From: Philip Forster
Sent: 09 September 2019 13:46
To: planning_admin
Subject: FW: P/2019/0598 & 0597

Flood officer response

From: Neil Taunt
Sent: 05 September 2019 15:36
To: Philip Forster
Cc: Neil Taunt
Subject: P/2019/0598 & 0597

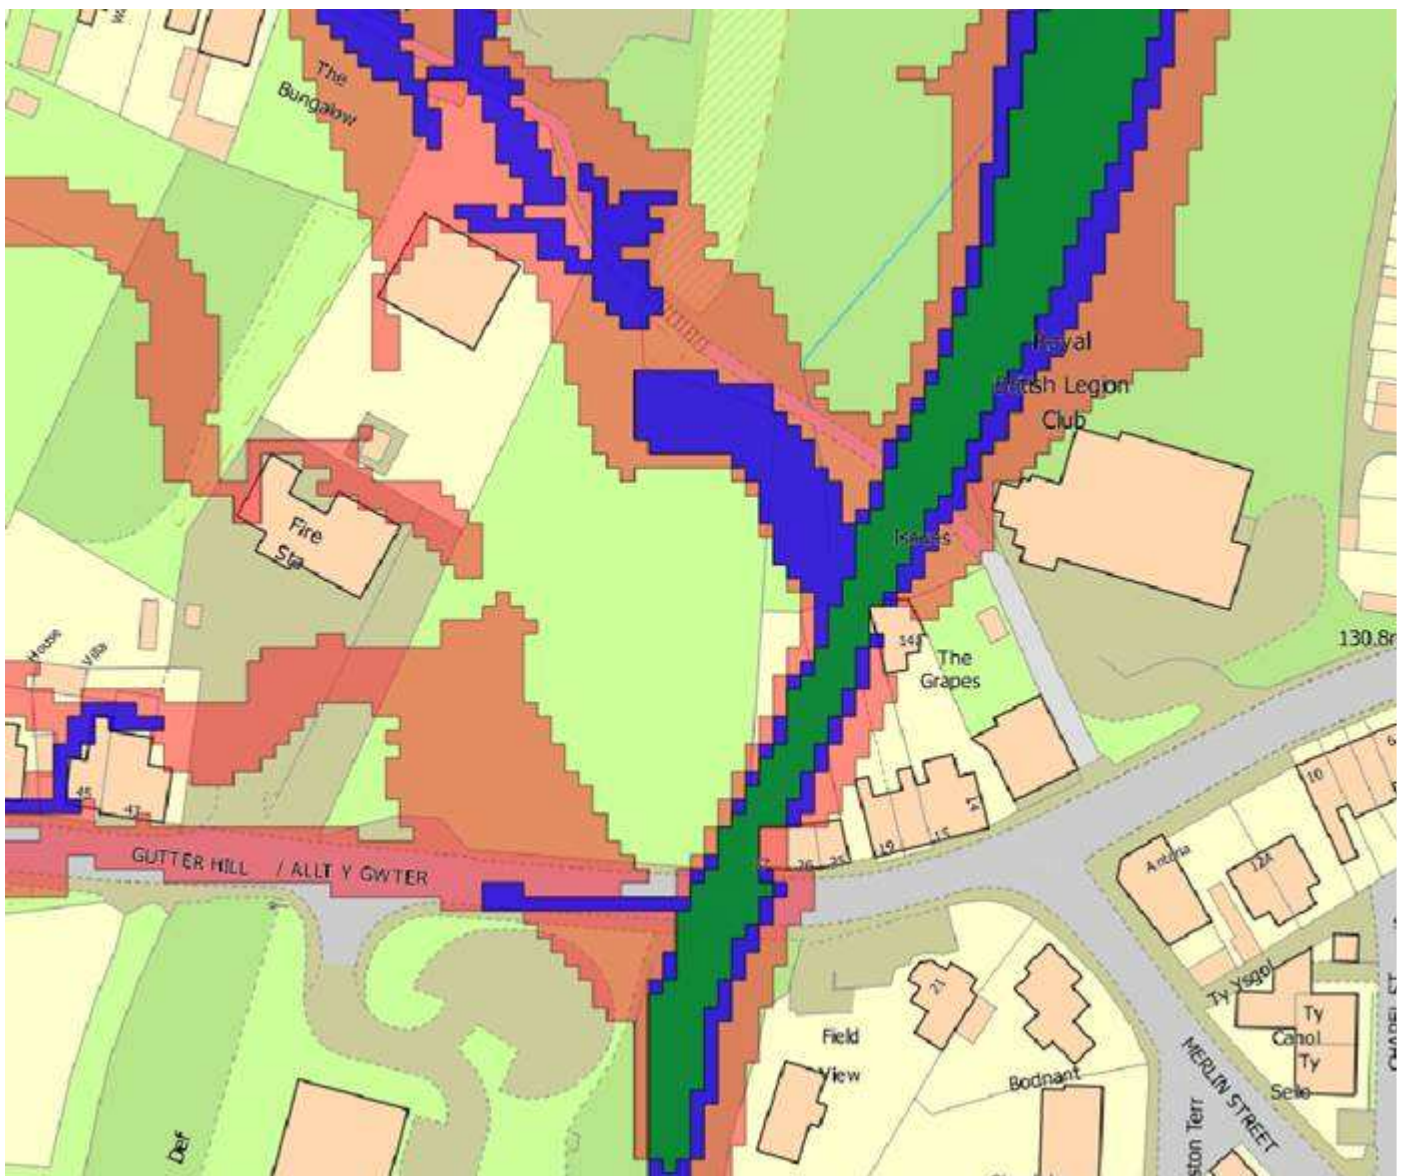
The site is located in DAM Zone A as defined within TAN15. NRW's surface water flood map identifies areas of both Low and Medium flood risk as detailed on the map extract below.
